UNITED STATES PATENT AND TRADEMARK OFFICE

10/763,630

<b>Office Action Summary</b>	<b>Application No.</b> 10/763,630	<b>Applicant(s)</b> DENNIS, RUSSELL	
	<b>Examiner</b> Michael P. Ferguson	<b>Art Unit</b> 3679

## **DETAILED ACTION**

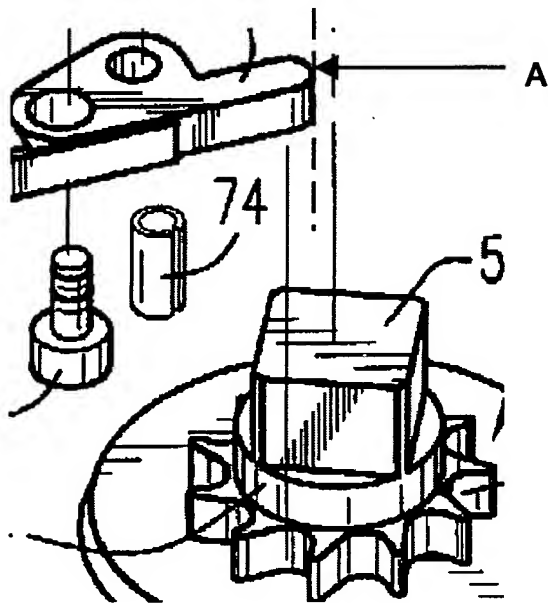
a pawl **70** supported on the body and rotationally movable to engage one end thereof with the tensioner;

a head **58,60** formed on the end of the tensioner for rotation thereof,

the pawl having an engaging end **A** (having a tangential end surface **A**) perpendicular to the pawl and engaging the surface of a portion of the tensioner, thereby blocking rotational movement of the tensioner;

a pair of pawls **70** each supported on the body and rotationally moveable to engage one end thereof with one of the tensioners, the pawl having an engaging end (having linear end surface **A**) perpendicular to the pawl, the engaging end further having a planer surface engaging an area on the surface of a portion of the tensioner thereby blocking movement of the tensioner,

each of the tensioners having a head **58,60** formed on the end thereof (Figures 4 and 6).

Examiner notes that a "planar" surface is defined as "a surface in which if any two points are chosen a straight line joining them lies wholly in that surface". Accordingly, all that is structurally required of a "planar" surface is that a linear surface is defined; clearly a linear contact surface exists along linear end surface **A** of the House et al. reference. If the applicant intends to recite an end surface which has both

Examiner disagrees. As to claims 1 and 8, as best understood, House et al. disclose a device wherein the pawl **70** has an engaging end **A** (having linear end surface **A**) perpendicular to the pawl, the engaging end further having a planer surface engaging an area on the surface of a portion of the tensioner, thereby blocking movement of the tensioner (Figures 4 and 6).

Examiner notes that a "planar" surface is defined as "a surface in which if any two points are chosen a straight line joining them lies wholly in that surface". Accordingly, all that is structurally required of a "planar" surface is that a linear surface is defined; clearly a linear contact surface exists along linear end surface **A** of the

a width and a length component which are perpendicular to a longitudinal length of the pawl, then such claim limitations should be clearly recited within the claim.

House et al. reference. If the applicant intends to recite an end surface which has both a width and a length component which are perpendicular to a longitudinal length of the pawl, then such claim limitations should be clearly recited within the claim.
